AMENDMENT UNDER 37 C.F.R. § 1.111
U.S. Application No. 10/511,084

AMENDMENTS TO THE DRAWINGS

REMARKS

FIG. 3A

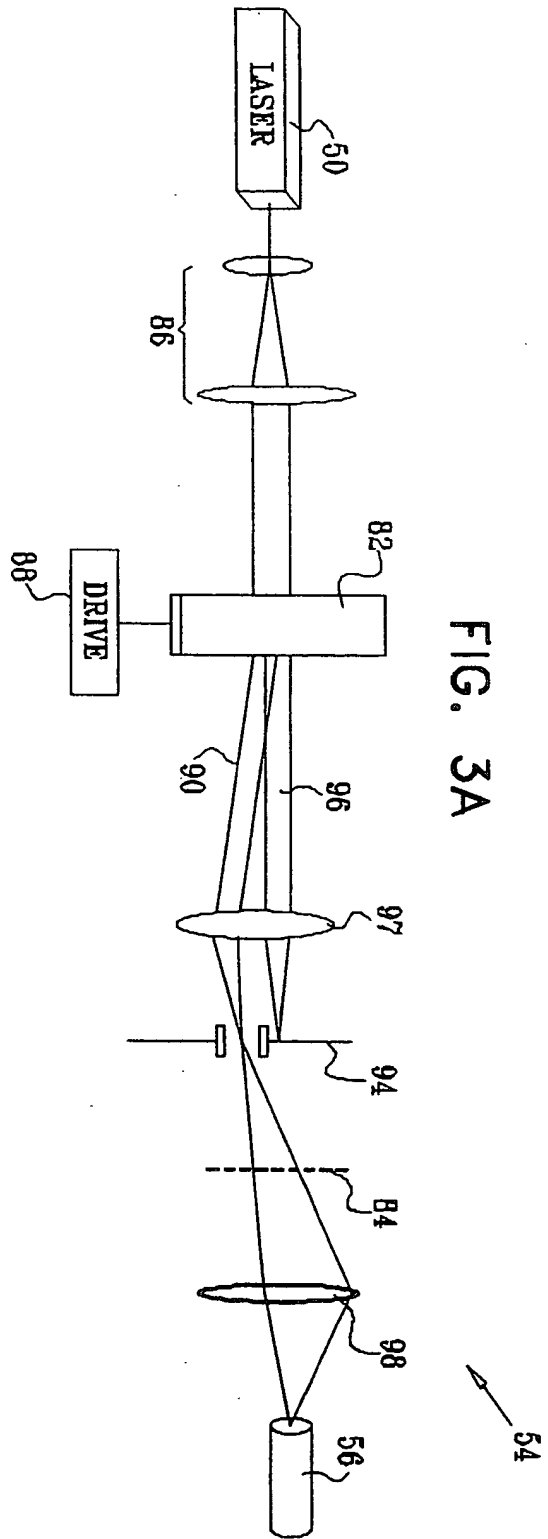
Drawing sheet number 3 containing Figure 3B has been amended. Specifically, numeral 54 , designating a speckle reduction module, has been changed to “54”.

Specifically, objection to Figures 3A and 3B is made for allegedly failing to comply with 37 CFR 1.8(p)(5) because reference character "54" has been used to designate both the optical

system in Figure 3A and the optical system in Figure 3B. Applicants respectfully submit that this objection is fully overcome by the present amendment of Figure 3B.
